REGULATORY INFORMATION DISTRIBUTION SYSTEM (RIDS)

SUBJECT: Responds to violations noted in Insp Rept 50-410/88-14.
 Corrective actions: four FSAR chapter changes evaluated.

August 25, 1988
NMP2L 1158U.S. Nuclear Regulatory Commission
Attn: Document Control Desk
Washington, D.C. 20555Re: Nine Mile Point Unit 2
Docket No. 50-410
NPF-69

1. MODIFICATION TITLE: Change to FSAR Ch. 14 Table 14.2-240.

FIGURE 14.2-233-1

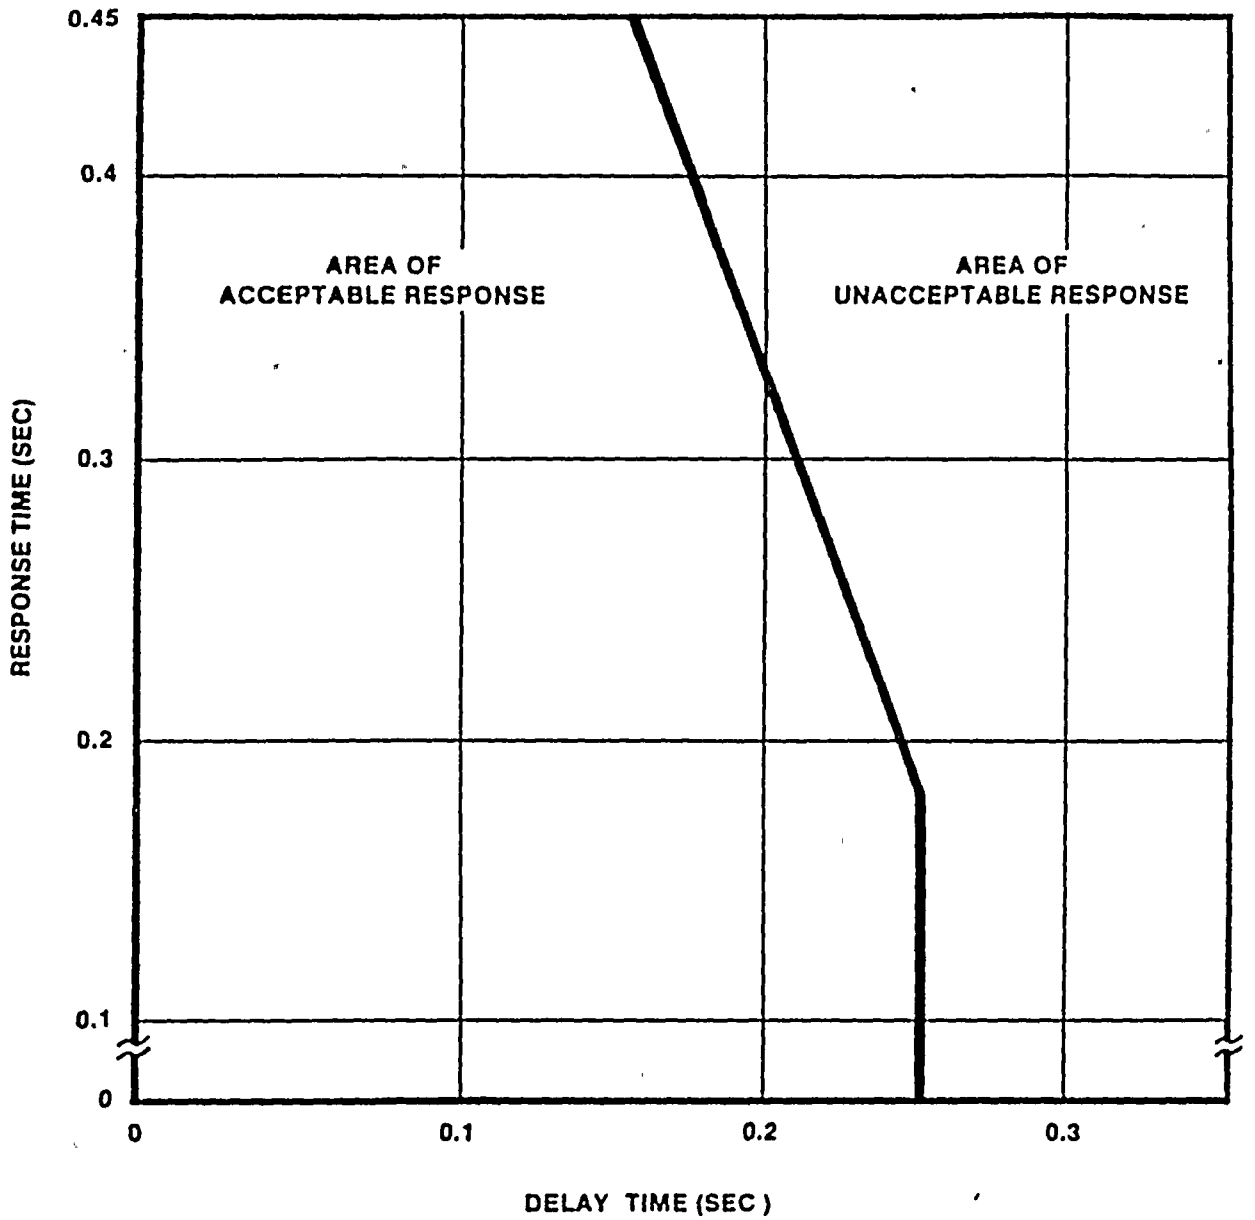
2. Maximum rate of change of valve position shall be 10 ± 1 percent/sec. $5+1, -0.5$

During TC-3 and TC-6 while operating on the high speed (60 Hz) source, gains and limiters shall be set to obtain the following response.

3. Delay time for position demand step shall be:

0.22
 ≤ 0.15 sec

4. Response time for position demand step shall be:

1.05
 ≤ 0.45 sec

Changes to startup test procedures contained in FSAR Tables 14.2-233 and 14.2-234 are attached. These changes have been reviewed for accuracy against the revision to GE startup test specification for the recirculation flow control system, 23A4138, contained in FDDR KGI-6133, Rev. 0.
